Bulletin	Ampex 350 15 in/s NAB recording equalization
Date	15 Sept 05 (original issue)
Revision	Rev 2 (revised 5 Jan 2012 to fix wiring error in Figure 2 and update photos)
Total pages	4

The Ampex 350 record/play electronics cannot be adjusted to provide proper record equalization when using modern tape types with 15 ips NAB equalization.

Figure 1. Disconnecting L401

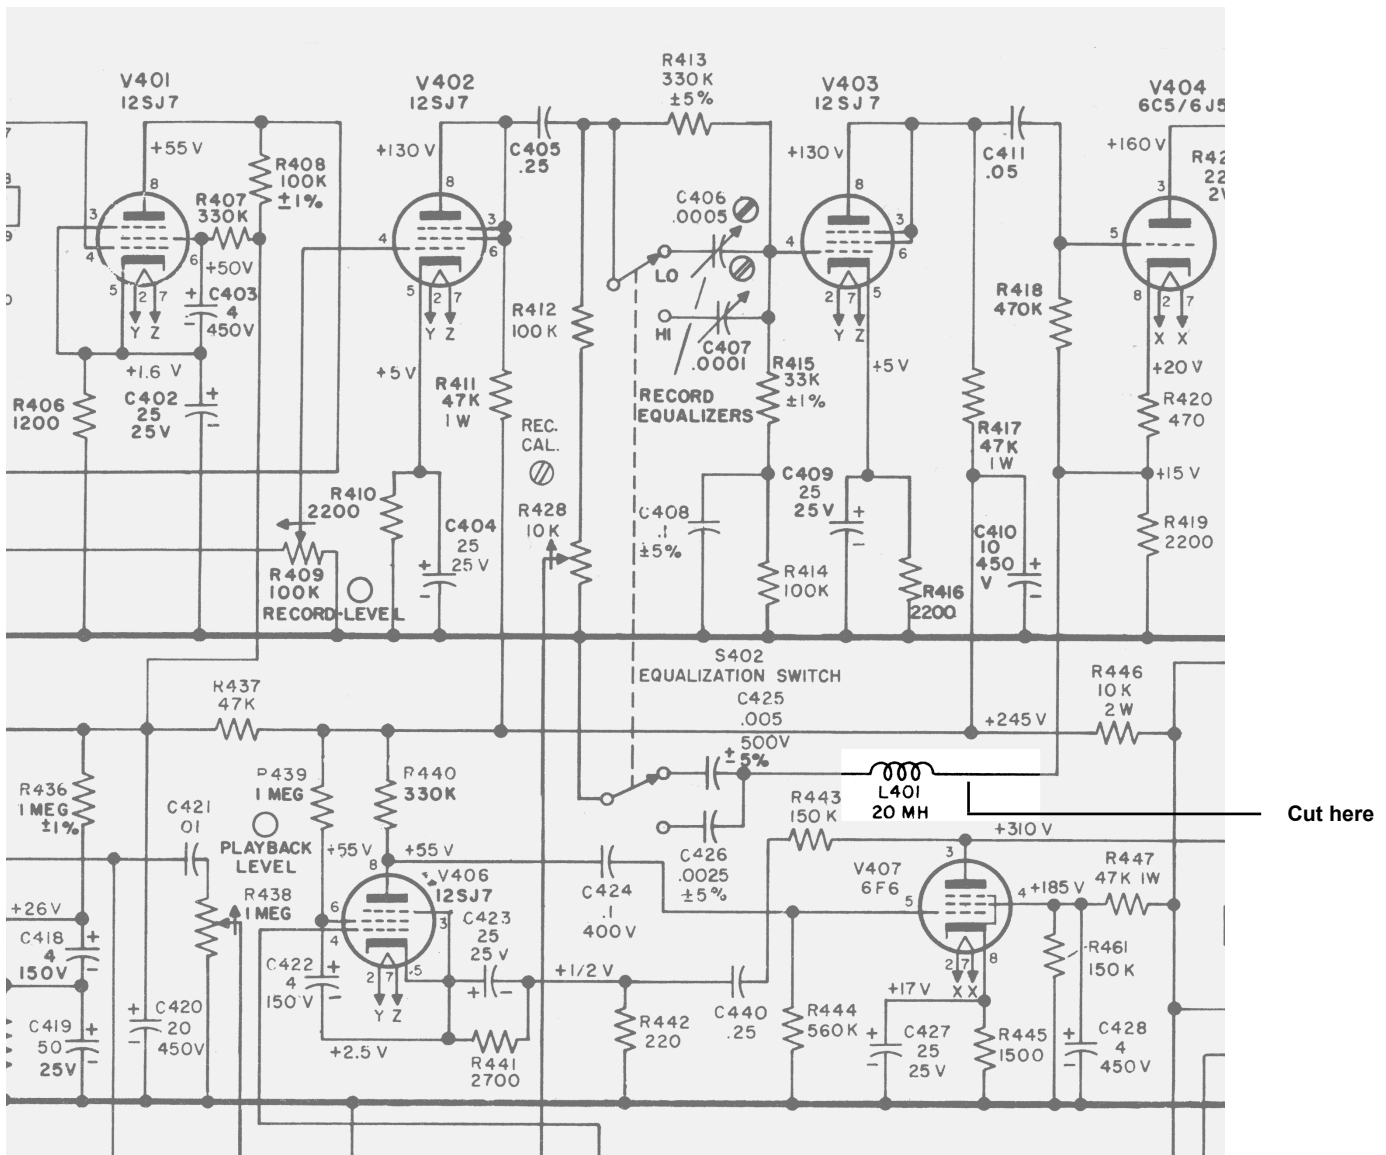
- 1 Disconnect ac power from the Ampex 350 power supply and disconnect the power supply cable from the electronics chassis.
- 2 Remove the bottom cover of the record/play electronics.
- 3 Locate L401; this is the 20 mH inductor mounted on the inside rear of the front panel between the record level potentiometer and the equalization switch. The location of L401 is obvious as there are no similar components.
- 4 Cut the green wire connecting one end of the L401 to V404 (6C5/6J5). After cutting the wire, cover the cut end with a short length of heat-shrink tubing and tuck the loose wire into a convenient location.

Figure 2. Record EQ switch modification

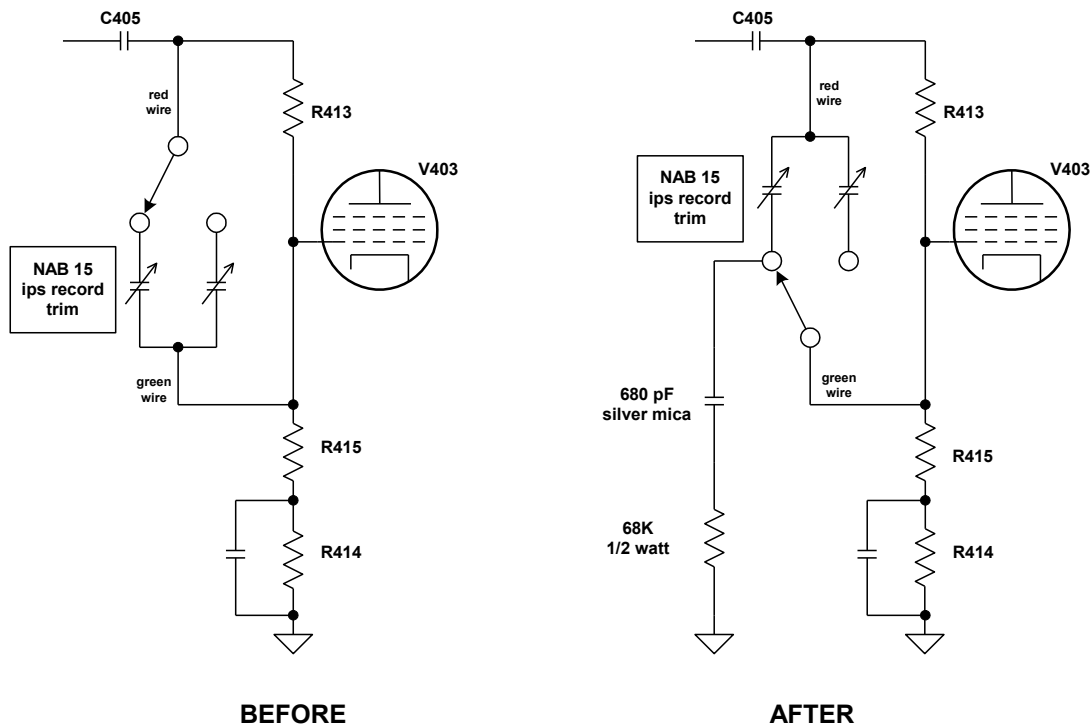
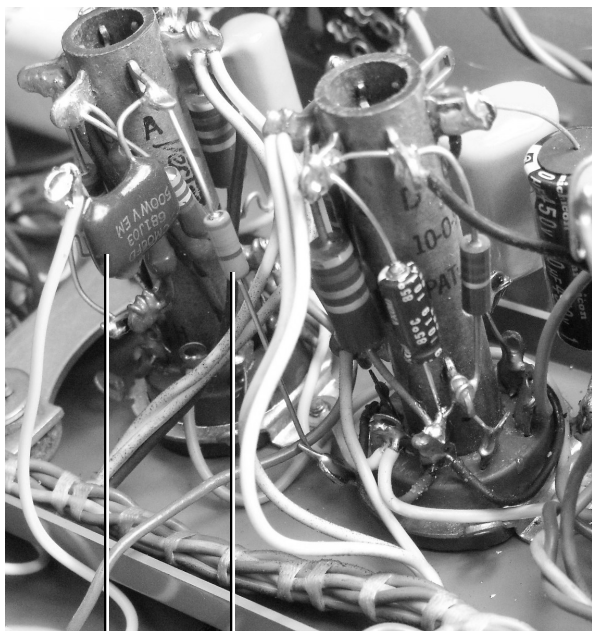
- 1 Locate the green wire where it joins the junction of the two trimmer capacitors (C406 and C407). Carefully unsolder the green wire at this location.
- 2 Locate the red wire where it joins the wiper terminal of the record equalization switch—this switch has several sections, so be sure to locate the correct wiper terminal. Carefully unsolder the red wire at the location.
- 3 Move the green wire to the wiper terminal of the record equalization switch. If the wire is not long enough, replace it with a longer length of green insulated wire (18 to 22-gauge stranded insulated wire is fine).
- 4 Move the red wire to the junction of the two trimmer capacitors.

Figure 3. Flattening filter installation

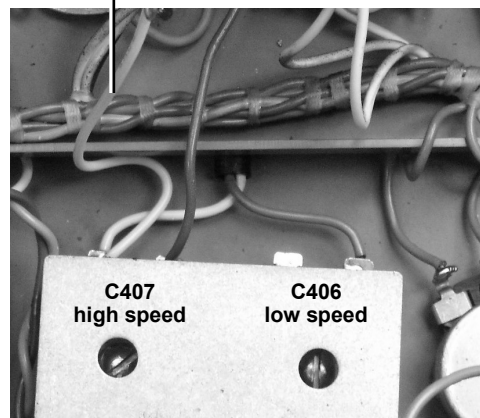
- 1 Solder one end of the 68 kilohm resistor to a ground lug on octal socket V402. Solder the other end to the **unused** solder terminal on V403 along with one end of the 680 pF silvered-mica capacitor (see Figure 3).

- 2 Cut short the other end of the 680 pF silvered-mica capacitor lead to form a small hook. Then attach a small length of wire (preferably yellow to match existing wiring) and solder one end to the hook end of the 680 pF capacitor.

- 3 Solder the other end of the yellow wire to the *non-common* terminal of the C407 (the high-speed record EQ trimmer)—this is to the left of C406 (the low-speed trimmer) as you look into the underside of the record/play electronics with the rear of the chassis facing you. “Non-common” is the terminal that is *not* connected to the other EQ trimmer.
